Access Compliance Report

Public Rights-of-Way

(Curb Ramps)

Intersection ID: 43934	Main Street: ALBEMARLE_RD	Cross Street: CIRCUMFERENTIAL_RD	Location: NW
ADA ID: ACF88DED7250	Ramp Type: PerpDiag	Initial Pass/Fail: Fail	Overall Compliance: No
Codes/Mitigation Info/Possible Solution		Field Measurements/Component Compliance	
Severity Score: 8.75

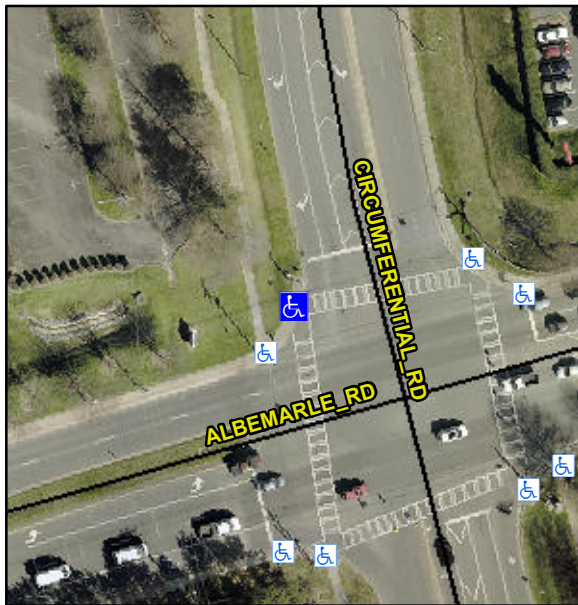
Not Found, R304.5.1

Compliance	Description	Data	Compliance	Description	Data
N/A	Ramp Length (in)	60.0	Yes	Ramp Slope (%)	5.7
No	Ramp Width (in)	46.0	Yes	Ramp XSlope (%)	0.5
N/A	Flare Type LT	N/A	N/A	Flare Type RT	N/A
N/A	Flare Slope LT (%)	N/A	N/A	Flare Slope RT (%)	N/A
N/A	Flare Traversable LT?	N/A	N/A	Flare Traversable RT?	N/A
N/A	Landing Length (in)	N/A	N/A	DWS Provided?	N/A
N/A	Landing Width (in)	N/A	N/A	DWS Contrast?	N/A
N/A	Landing Slope (%)	N/A	N/A	DWS Length (in)	N/A
N/A	Landing X Slope (%)	N/A	N/A	DWS Full Width?	N/A
N/A	Landing Curb? (Y/N)	N/A	N/A	DWS Offset (in)	N/A
N/A	Shared Landing?	N/A			
N/A	Gutter Ponding?	N/A	N/A	Gutter Slope (%)	N/A
N/A	Gutter Lip Ht (in)	N/A	N/A	Gutter X Slope (%)	N/A
N/A	Painted X Walk1?	Yes	N/A	Painted X Walk2?	Yes
	X Walk 1 Direction	To S		X Walk 2 Direction	To E
N/A	X Walk 1 Width (in)	106.0	N/A	X Walk 2 Width (in)	102.0
	X Walk 1 Slope (%)	0.5		X Walk 2 Slope (%)	2.1
	X Walk 1 X Slope (%)	0.5		X Walk 2 X Slope (%)	1.1

Remove & Replace Curb Ramp With Two New Directional Ramps or Equivalent.
